Refer to: HSA-10/WZ-119

Thank you for your letter of October 20, 2003, requesting Federal Highway Administration (FHWA) acceptance of your company's J-4 Flagger's Workstation as a crashworthy traffic control device for use in work zones on the National Highway System (NHS). Accompanying your letter was a report of crash testing conducted by the Texas Transportation Institute and a video of the tests. You requested that we find these devices acceptable for use on the NHS under the provisions of National Cooperative Highway Research Program (NCHRP) Report 350 "Recommended Procedures for the Safety Performance Evaluation of Highway Features."

# J4 FLAGGER'S WORKSTATION

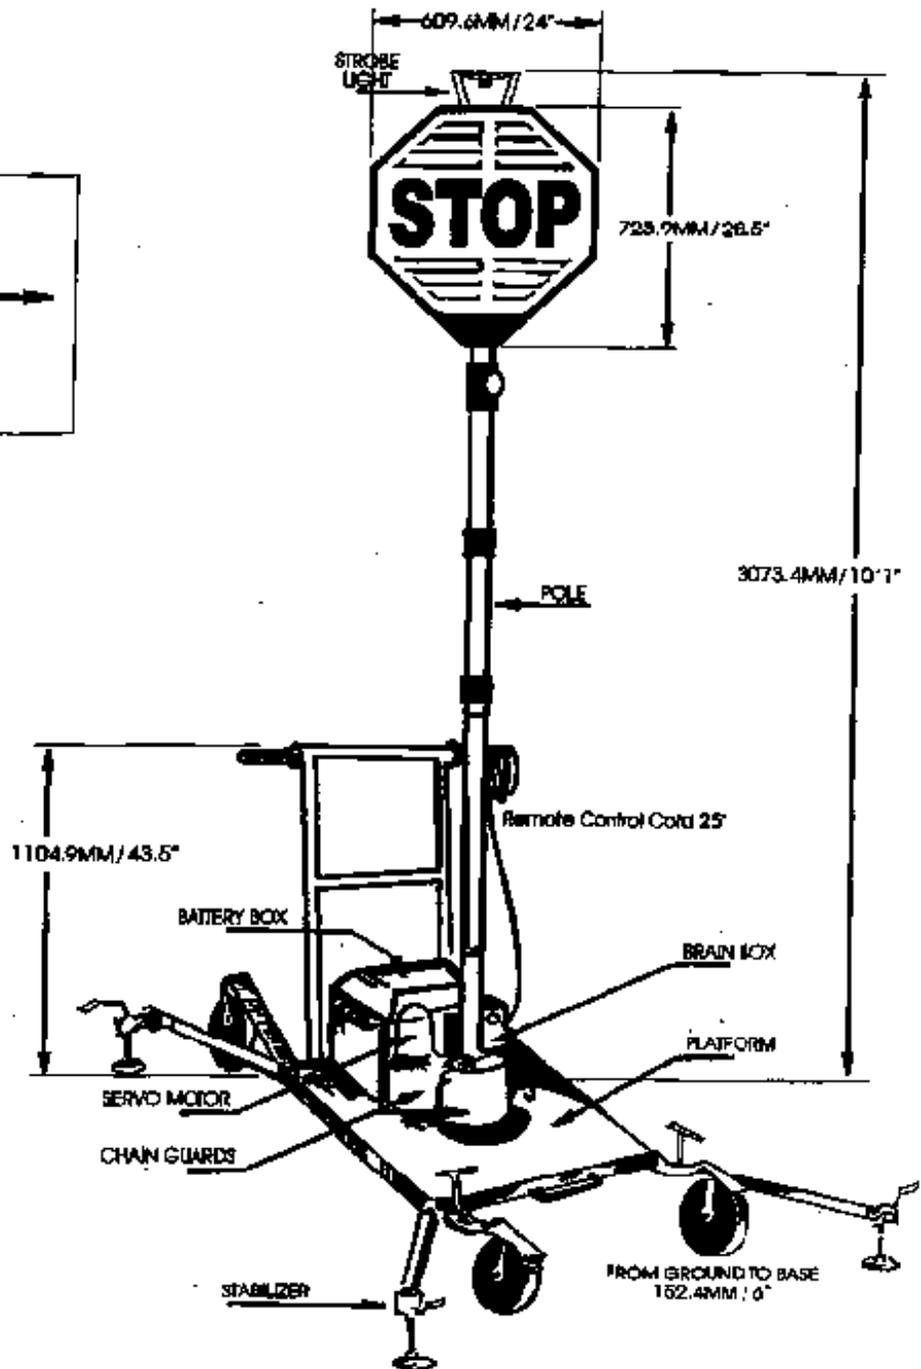
The J-4 Flagger's Workstation is a Category III portable work zone traffic control device. It is remotely operated by the flagger who is standing in a safer location off of the traveled way. The device consists of a 12-volt battery pack, motor system, push bar handle, 180 degree rotating fiberglass telescopic pole supporting a dual face sign supported by a small steel frame. The portable device is supported by four retractable outriggers when in use and caster wheels when moving from site to site. The outriggers are approximately 1030 mm by 1090 mm in the plan. The device is operated using a control box mounted on a 7.62-m extension cord. The overall height of the device was approximately 3.5 meters, and it weights approximately 93 kg. Details of the workstation are shown in the enclosed drawings for reference.

Damage was limited to the front right corner of the test vehicle in the head-on impact with a very minor amount of floor pan deformation toward the occupants. The vehicle sustained moderate damage to the right front corner with a maximum exterior crush of 100 mm in the 90 degree impact. No deformation or intrusion into the passenger compartment resulted from the test. The results of the testing met the FHWA requirements and, therefore, the devices described above and shown in the enclosed drawings for reference are acceptable for use on the NHS under the range of conditions tested, when proposed by a State. The 12 inch diameter reel for storing the communication cable, as described and illustrated in your email messages of October 29, will be acceptable without additional crash testing.
